TB-21-692

Character and Use: One-Family Residence w/ attached Garage

**RCRBD Record Set
T.A.**

COVER FOR
MICAL HUYSER
27225 COUNTY ROAD 14
ROUTT COUNTY, COLORADO
ALBERTINI CONSTRUCTION INC. (970)879-9650

SITE PLAN

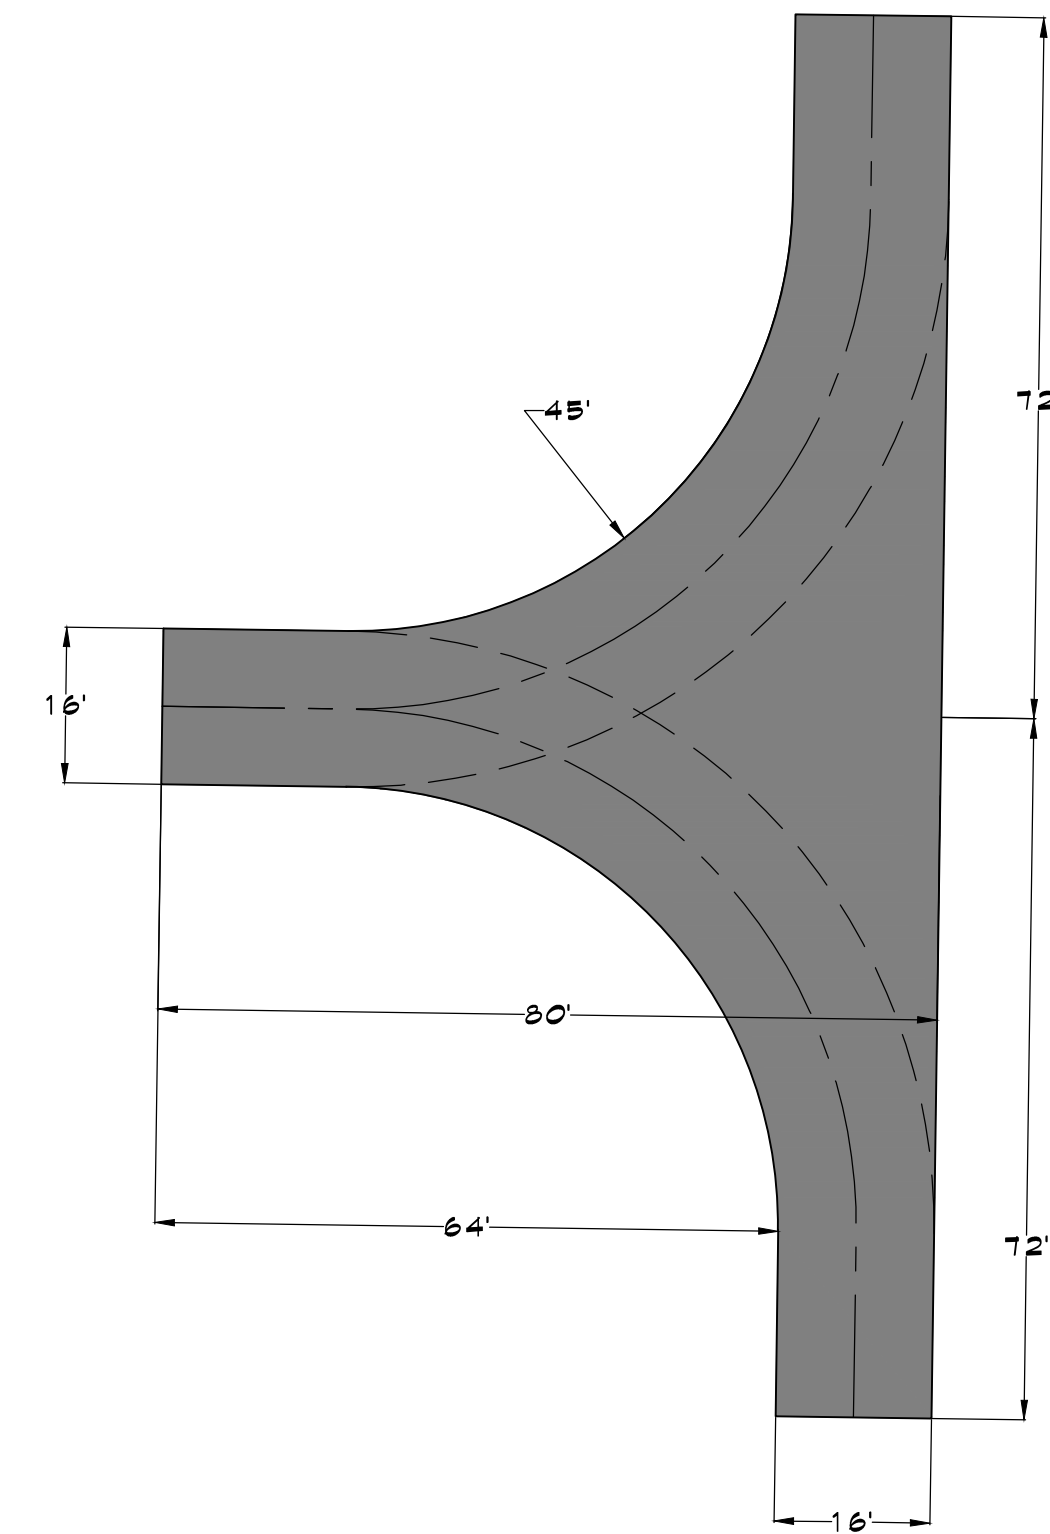
Conditionally approved- pending resubmittal of site plan with access width, grade, turning radius, turnaround, and turnouts meeting Fire Dept. access requirements or if unable to meet requirements submittal of fire sprinkler and monitored fire alarm plans and permits. No inspections past foundation until the above is resolved.)
www.steamboatsprings.net for details.
